inter-office communication

Date: May 7, 2008
Subject: LAK 44 L/A break (SR 44 Corridor Study Analysis)

Reference is made to your April, 2008 email requesting that our office review the technical memorandum for SR 44 in Lake County.

Figure 1

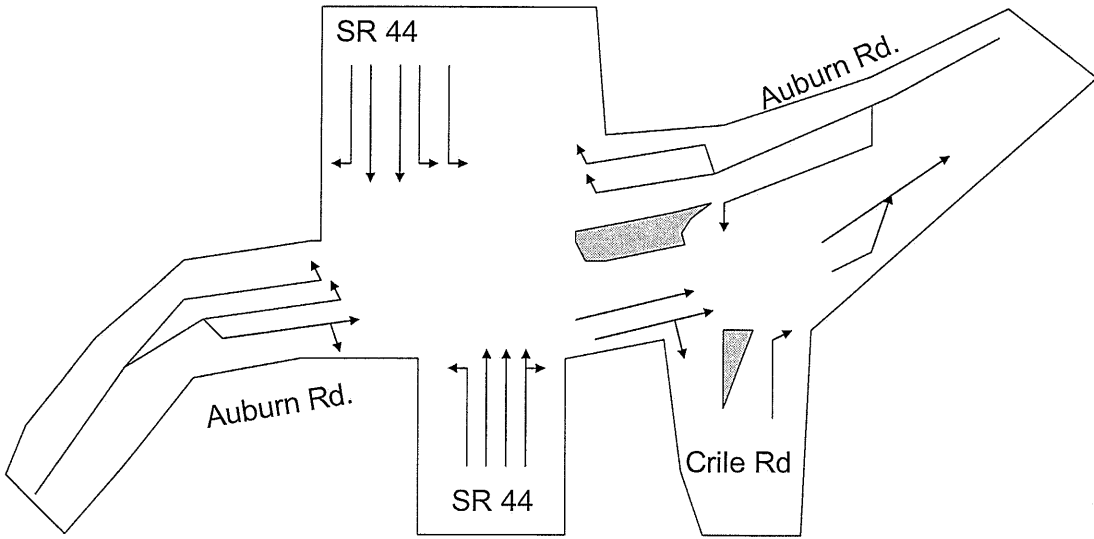
The study demonstrates that the proposed L/A break will shift traffic from Auburn Road to the new roadway connection. The study also indicated that improvements are needed through the I-90 interchange to bring it to a satisfactory operation. The study proposed a design which is not feasible. The I-90 EB loop ramp is proposed to have two lefts and two rights. This is not an acceptable design geometrically. Other interchange configurations need to be explored. Our office has provided a possible interchange configuration (Figure 1) which could provide an acceptable LOS adding fewer lanes to the interchange. It would involve adding an additional exit ramp. The ramps would function as directional ramps (northbound and southbound). Both of these ramps would be signalized. This configuration would also require widening the SR 44 northbound bridge to accept the 3rd northbound lane. This design can be phased into the Auburn road improvements. The added through lane would be required northbound beginning south of the Auburn road intersection. This would need to be developed prior to the northbound left turn at Auburn Road intersection. This lane will need to have overhead signing since it will drop to the I-90 westbound left turn lane.

Possible interchange configuration:

- Add a new EB to SB ramp
- Convert the existing EB loop ramp to NB only
- Widen bridge to allow dual left northbound; Convert SB slip ramp to right turn lane.
